## Service Information Bulletin

SUBJECT	DATE
TCM SPN 520970/FMI 7	March 2016

### Additions, Revisions, or Updates

Publication Number / Title	Platform	Section Title	Change
DDC-SVC-MAN-0140	DT12	SPN 520970/FMI 7	Update to Step 6
DDC-SVC-MAN-0084	DT12	SPN 520970/FMI 7	
DDC-SVC-MAN-S084	DT12	SPN 520970/FMI 7

d500248

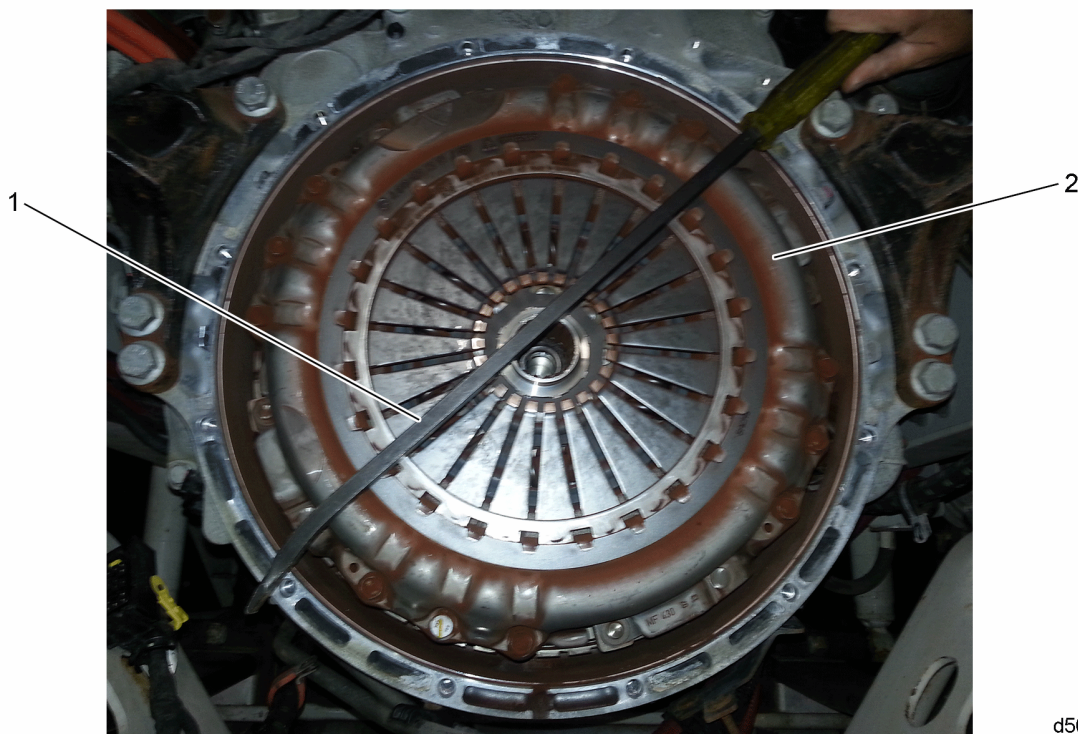
2. Start the engine and idle for two minutes.
3. Is the transmission air supply pressure greater than 689 kPa (100 psi)?
  - a. Yes; Go to step 6.
  - b. No; Go to step 4.
4. Shut the engine OFF.
5. Inspect transmission air supply lines and fittings for leaks; repair as necessary. Repeat all steps in this procedure.
6. Under the Actions menu, select transmission heading and then choose Clutch Apply Leak Test; execute routine. Does the result indicate a successful completion, test pass? Note that test may have to be performed three times in order to get a "pass" result.
  - a. Yes; Go to step 7.
  - b. No; Go to step 8.
7. Under Instrumentation tab, select Transmission Learned Values. Is Instrument Learned Value Clutch Minimum greater than 33 mm or Clutch Limit Stop Maximum Value greater than 51mm?

- a. Yes; Go to step 8.
  - b. No; obtain a driving log file and contact Detroit™ Transmission Support at 855-253-0428 for further assistance.
8. Remove transmission. Refer to section "Removal of the Transmission".
  9. Keep the pressure plate and clutch disk installed on the engine.
    - a. Lay a straightedge (1) on the raised portions on the pressure plate (2).
